**SERVICE PROGRAM BULLETIN**

**APPLICABILITY:** 2015 MY Legacy and Outback

**NUMBERS:** WTG-67R

**SUBJECT:** Engine No-Start Condition in Cold Climates

Under-hood Main Fuse Box (M/B)

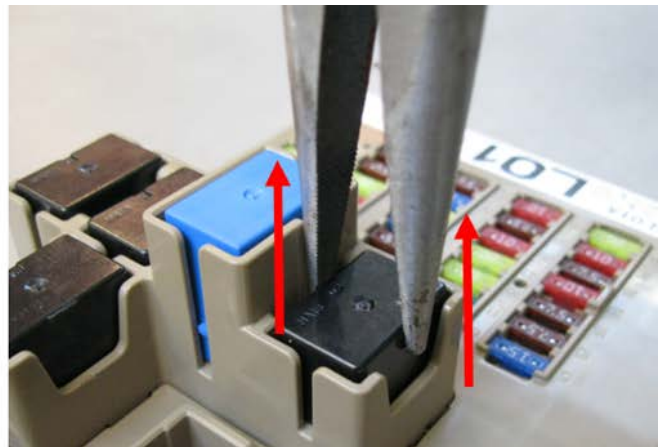
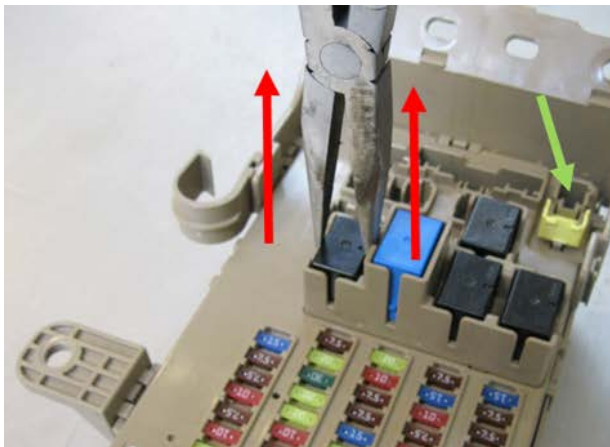
The 4 IG1, IG2, ACC1, ACC2 relays are located in the vehicle's interior fuse box (F/B). The EGI Main Relay is located in the under-hood fuse box (M/B).

**IMPORTANT:** Relay identification:

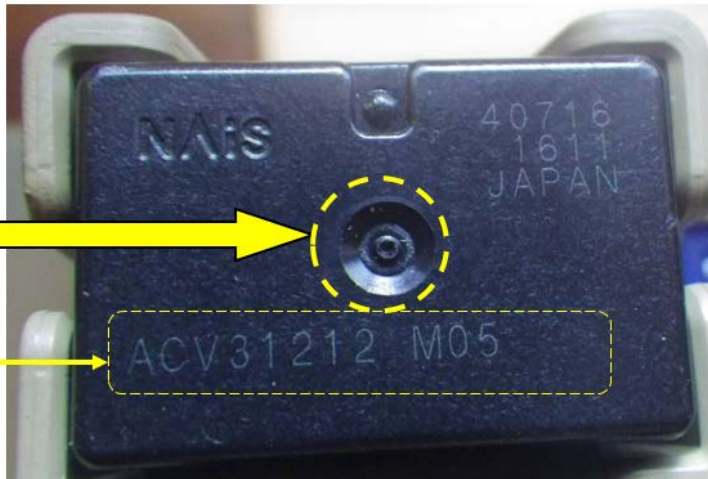
**NEW**  
**Revised Relays**

Identified by 2 small  
dents on the ends.

ACVN51212

**Current Relays**

Identified by the 1  
dent in the center.

ACV31212 M05

OLD: M07

NEW: M09

Main  
Relay

- Once **ALL 4** of the black relays have been replaced, reinstall the F/B and re-assemble in the opposite order of removal.
- **Using the reference photos below as a guide, inspect the EGI Main Relay in the M/B. Replace the relay if inspection reveals M07 on the top cover.**
